STAFF REPORT

SUBJECT: FP-2021-0053

Prescott Ridge No. 1

B. Final Plat (date: 9/24/2021)

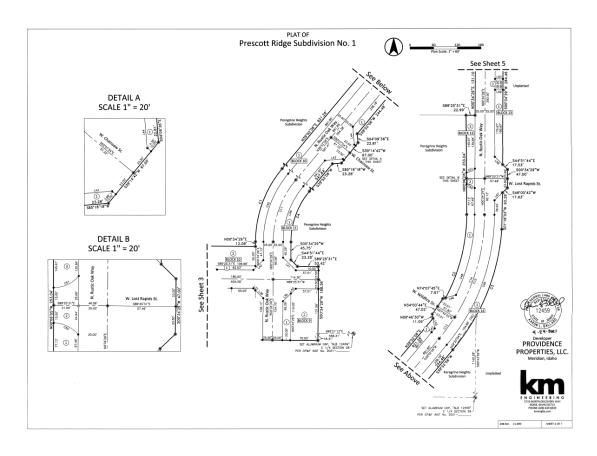
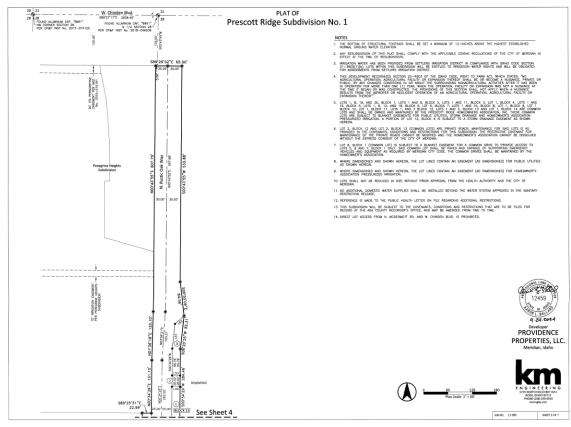
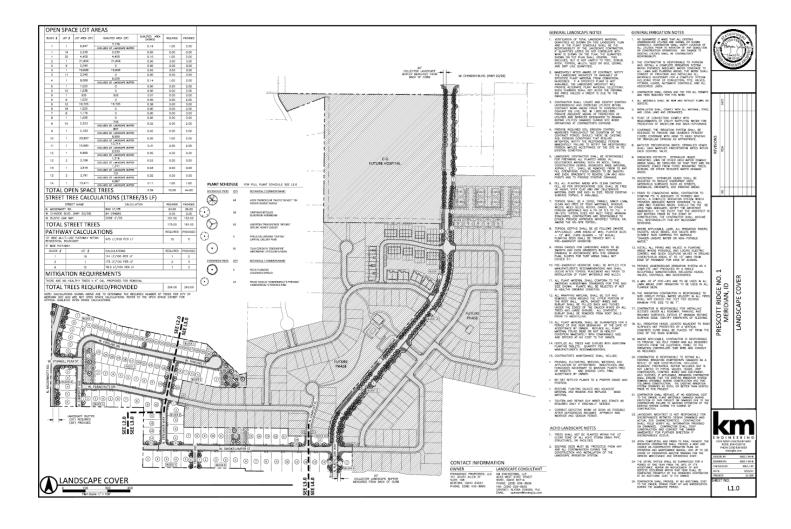
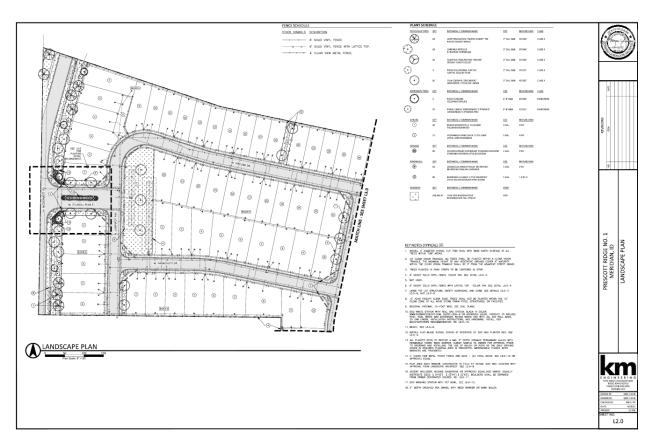
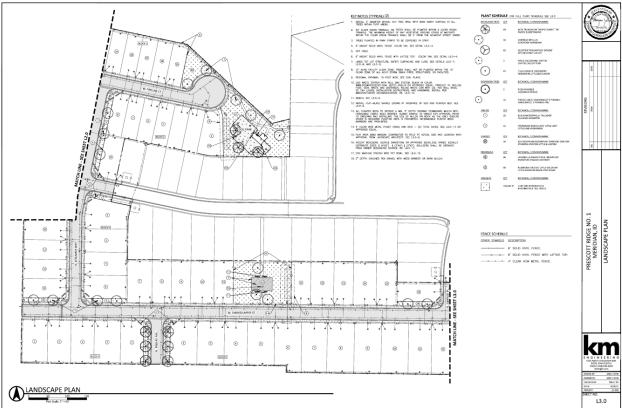
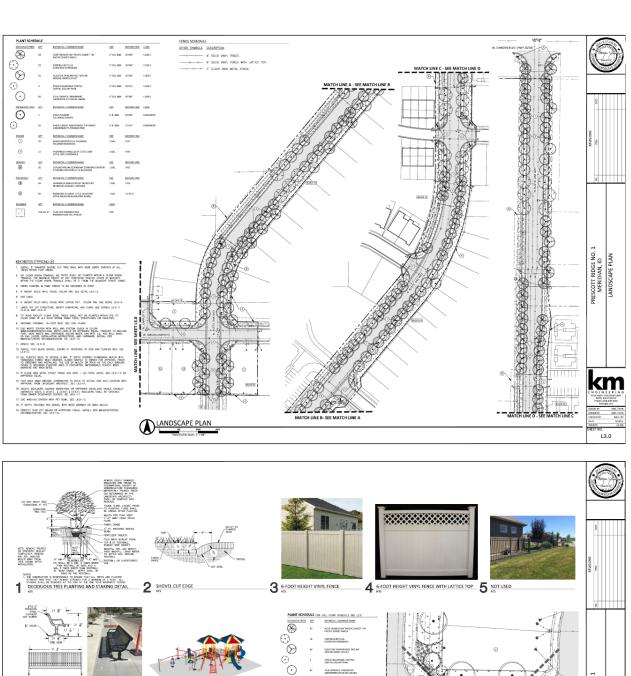
- a. Include Lot 80, Block 8 (i.e. hospital/medical center lot as shown on the preliminary plat) in the boundary of the final plat in accord with the phasing plan as required by the Development Agreement; or, amend the Development Agreement for the hospital portion of the development to exclude that parcel from the phasing plan, prior to signature on subject final plat by the City Engineer.

- b. Include the recorded instrument number of the point of commencement graphically depicted on Sheets 1 and 2.
 - c. Depict the correct parcel configuration of the property at the southwest corner of SH-20/26 and N. Rustic Oak Way as shown on ROS #13153, property boundary adjustment for Providence Properties, LLC, Raymond Roark and Lonnie Kuenzli.

- d. Note #14: "Direct lot access from N. McDermott Rd., N. Rustic Oak Way and W. Chinden Blvd. is prohibited, unless otherwise approved."

An electronic copy of the revised plat shall be submitted prior to signature on the final plat by the City Engineer.

C. Landscape Plan (date: 9/23/2021), Fencing Plan & Amenity Details

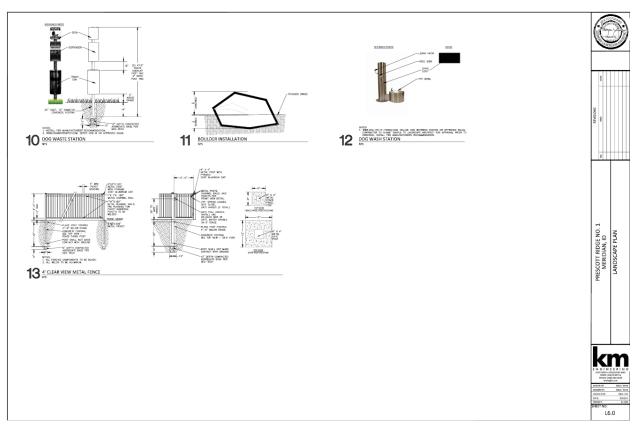
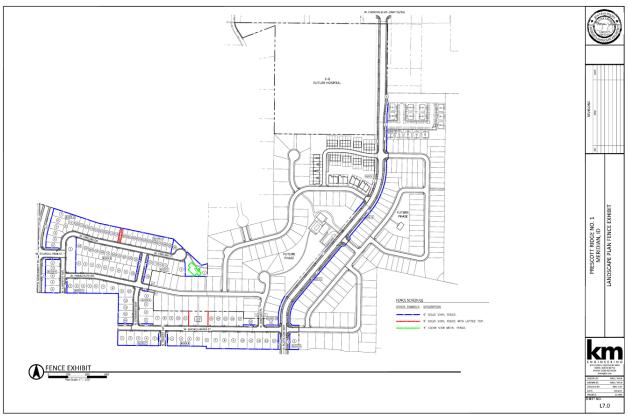
- 5. The landscape plan shown in Section V.C, dated 9/23/21, shall be revised as follows:
 - a. Depict shrubs (along with the proposed trees) within the street buffers along W. Chinden Blvd., N. McDermott Rd. and N. Rustic Oak Way as set forth in UDC 11-3B-7C.3a.

- b. Landscaping shall be depicted along *all* pathways in accord with the standards listed in UDC <u>11-3B-12C</u>; include a *mix* of trees and <u>shrubs</u> along with lawn and/or other vegetative groundcover.

- c. Depict noise abatement for the future SH-16 extension in the form of a berm or a berm and wall combination parallel to N. McDermott Rd. constructed in accord with the standards listed in UDC 11-3H-4D. A cross-section of the berm or berm/wall combination should also be included.

- d. If fencing is proposed along the west side of Lot 9, Block 1, depict a minimum 5' wide landscape buffer along the east side of Lot 8, Block 1 planted with shrubs, lawn or other vegetative groundcover as set forth in UDC <u>11-6C-3D.5</u>. Depict fencing on the plan if proposed.

An electronic copy of the revised landscape plan shall be submitted prior to signature on the final plat by the City Engineer.
